NON-CONCURRENCE PROCESS COVER PAGE

NCP-2016-017
NCP PM 10/21/16

TITLE OF SUBJECT DOCUMENT RESPONSE TO JULY 28, 2016, LETTER REGARDING RETIREMENT OF NATIONAL FIRE PROTE		ADAMS ACCESSION NO. ML16253A111
DOCUMENT SIGNER Joesh G. Giitter		SIGNER TELEPHONE NO. 415-2884
TITLE Director, Division of Risk Assessment	ORGANIZATION NRR	
NAME OF NON-CONCURRING EMPLOYEE(S) Raymond HV Gallucci, PhD, PE		TELEPHONE NUMBER (301) 415-1255
TITLE Senior Fire PSA Engineer	ORGANIZATION NRR/DRA/APLA	
<input type="checkbox"/> DOCUMENT AUTHOR <input type="checkbox"/> DOCUMENT CONTRIBUTOR <input type="checkbox"/> DOCUMENT REVIEWER <input checked="" type="checkbox"/> ON CONCURRENCE		
NON-CONCURRING EMPLOYEE'S SUPERVISOR Stacey Rosenberg		
TITLE Branch Chief	ORGANIZATION NRR/DRA/APLA	
<input type="checkbox"/> I WOULD LIKE MY NON-CONCURRENCE CONSIDERED AND WOULD LIKE A WRITTEN EVALUATION IN SECTION B AND C. <input checked="" type="checkbox"/> I WOULD LIKE MY NON-CONCURRENCE CONSIDERED, BUT A WRITTEN EVALUATION IN SECTIONS B AND C IS NOT NECESSARY.

Response to July 28, 2016 Letter Regarding Retirement of NFPA-805 FAQ 08-0046

Fire PRAs – Risk Contributors

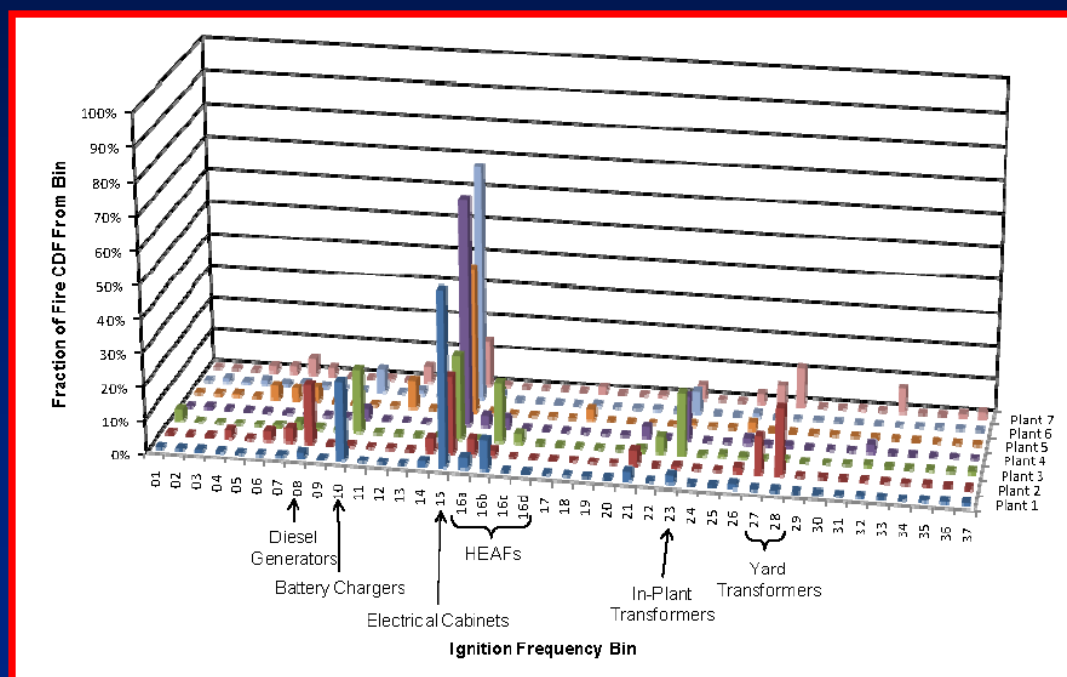
The figure below was especially controversial as it emphasized this alleged undue dominance of electrical cabinet fires due to fire PRA over-conservatism. This figure has been used in presentations, including by NRC staff, to emphasize that electrical cabinet fires can be dominant contributors to fire risk. While there is no argument that this is true, use of the figure gives the impression that such fires are nearly always the dominant risk contributors, which is not true. Subsequent review of eight NFPA-805 applications completed or well along in the review process indicated that the contributions from such fires spanned a range, from ~6 to 60% to the total fire core damage frequency.⁸⁷

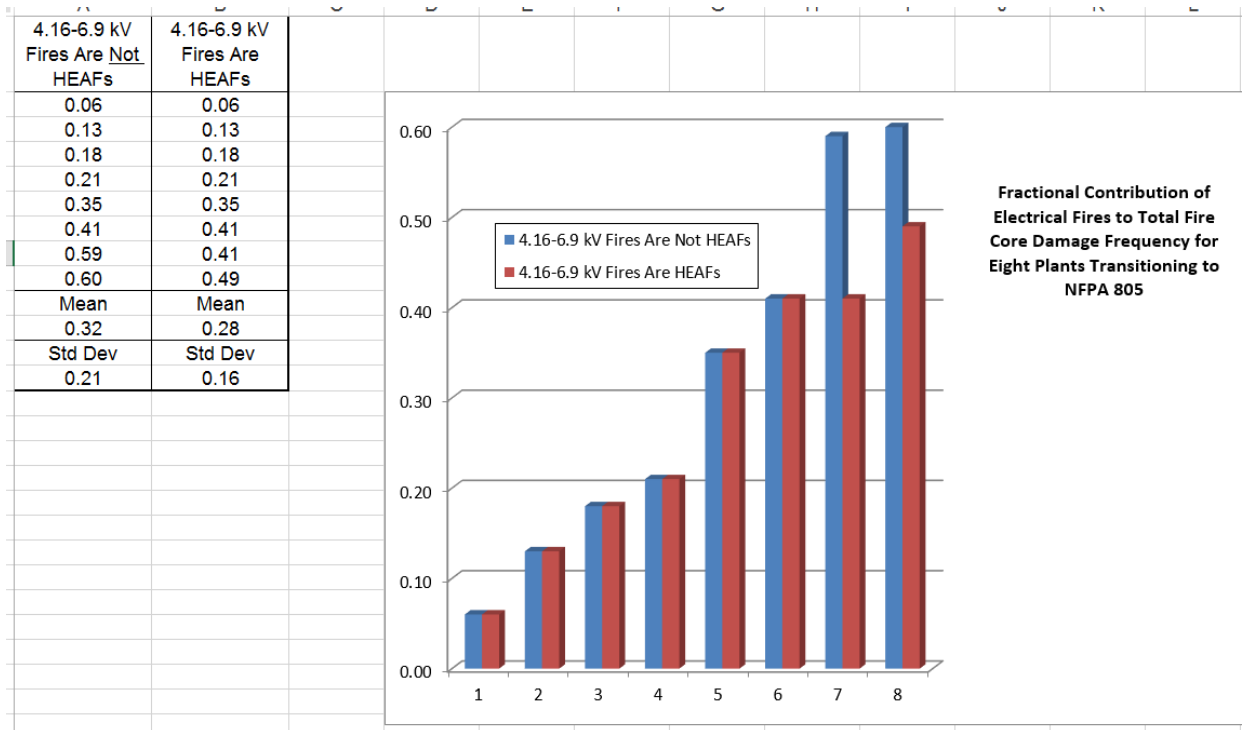
The following figure plots these results, still conveying the message that electrical cabinet fires CAN be important, but not creating the impression that they are nearly always so. This is especially true now in light of the revised fire ignition frequencies where Main Control Board fires are six times more likely than shown by the EPRI "Roadmap" as presented in 2010. Use of this updated figure should be preferred to that for the outdated EPRI figure when conveying this message.
